Project	IEEE 802.16 Broadband Wireless Access Working Group < http://ieee802.org/16 >	
Title	Enhancement for rate 2, 4-transmit antenna STC	
Date Submitted	2005-1-20	
Source(s)	<p>Jianzhong (Charlie) Zhang, Kiran Kuchi, Anthony Reid</p> <p>Voice: 972-374-0958, 972-374-1862 Fax: 972-894-5937 charlie.zhang@nokia.com, kiran.kuchi@nokia.com</p> <p>Nokia Research Center 6000 Connection Drive Irving, TX 75039</p> <p>Chan-Byoung Chae, Wonil Roh, Sung-Ryul Yun, Kyunbyoung Ko, JeongTae Oh, Hongsil Jeong, Seungjoo Maeng, Panyuh Joo, Jaeho Jeon, Jaeyeol Kim, Soonyoung Yoon</p> <p>cb.chae@samsung.com</p> <p>Samsung Electronics Co., Ltd.</p> <p>Young-Ho Jung, Seung Hoon Nam, Jaehak Chung, Yungsoo Kim</p> <p>Samsung Advanced Institute of Technology</p>	
Re:	IEEE 802.16e D5 Draft	
Abstract	Proposes an enhancement to rate 2, 4-transmit antenna space time code	
Purpose	To incorporate the changes proposed here into the 802.16e D5 Draft.

Enhancement for rate 2, 4 transmit antenna STC

Figure1: FER performance of circulated matrix B

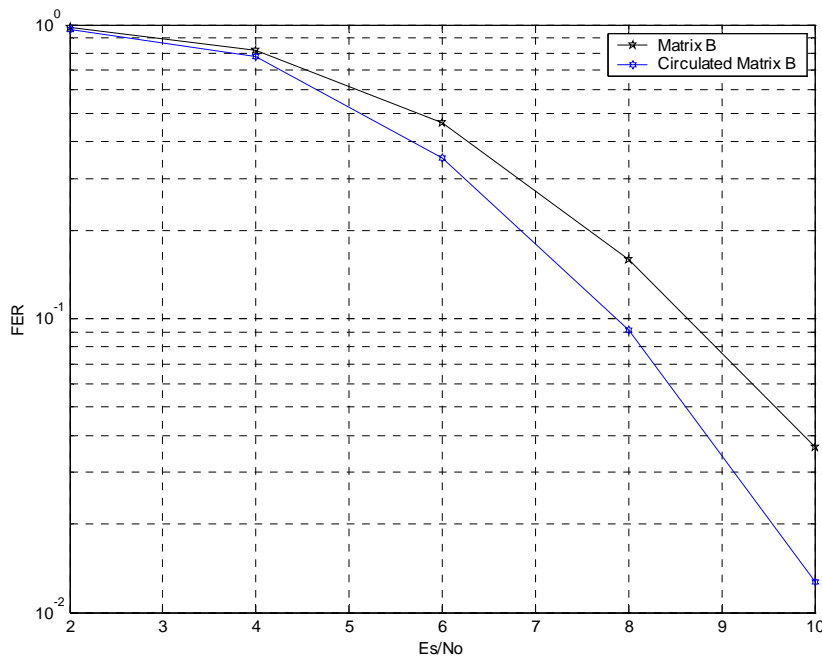
In Figure 1, we compared the FER performance of the circulated code to Matrix A for 4 Tx and 2 Rx case in for Ped A channel, rate 1/2 convolutional code, QPSK modulation using LMMSE receiver. We notice an increase in coding gain up to 1.0 dB. Similar gains are observed for other modulation and coding modes.
